Access Compliance Report Public Rights-of-Way (Curb Ramps)

Main Street: JOSHUA_LN Cross Street: DALL_LN Location: N

ADA ID: RPAT211026145843 Ramp Type: Type 1 - Perpendicular Diagonal Initial Pass/Fail: Fail Overall Compliance: No Severity Score: 2

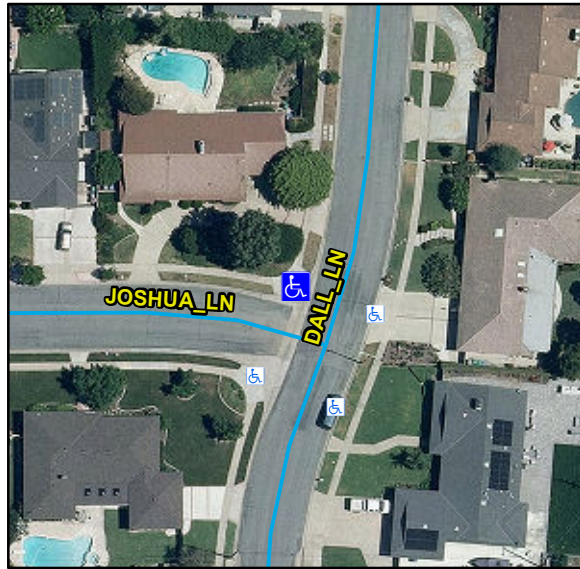
Compliance	Description	Data	Compliance	Description	Data
N/A	Ramp Length (in)	114	N/A	Flare Type LT	
Yes	Ramp Width (in)	48			N/A
Yes	Ramp Run Slope (%)	7.8	N/A	Flare Slope LT (%)	N/A
No	Ramp Cross Slope (%)	2.6	N/A	Flare Traversable LT	N/A
N/A	Landing Present	N/A	N/A	Flare Type RT	
N/A	Landing Length (in)	N/A			N/A
N/A	Landing Width (in)	N/A	N/A	Flare Slope RT (%)	N/A
N/A	Landing Run Slope (%)	N/A	N/A	Flare Traversable RT	N/A
N/A	Landing Cross Slope (%)	N/A	N/A	DWS Provided	N/A
N/A	Landing Movement Obstructed?	N/A	N/A	DWS Contrast	N/A
	Landing Movement Type	N/A	N/A	DWS Length (in)	N/A
N/A	Landing Shared	N/A	N/A	DWS Full Width	N/A
N/A	Clear Space	Yes	N/A	DWS Offset Left (in)	N/A
N/A	Clear Space To Crosswalk (in)	N/A	N/A	DWS Offset Right (in)	N/A
N/A	Marked Crosswalk 1	No	N/A	Marked Crosswalk 2	No
	Crossing 1 Direction	SW		Crossing 2 Direction	SE
	Marked Crosswalk 1 Width (in)	N/A		Marked Crosswalk 2 Width (in)	N/A

Remove & Replace Curb Ramp With Two New Directional Ramps or Equivalent.
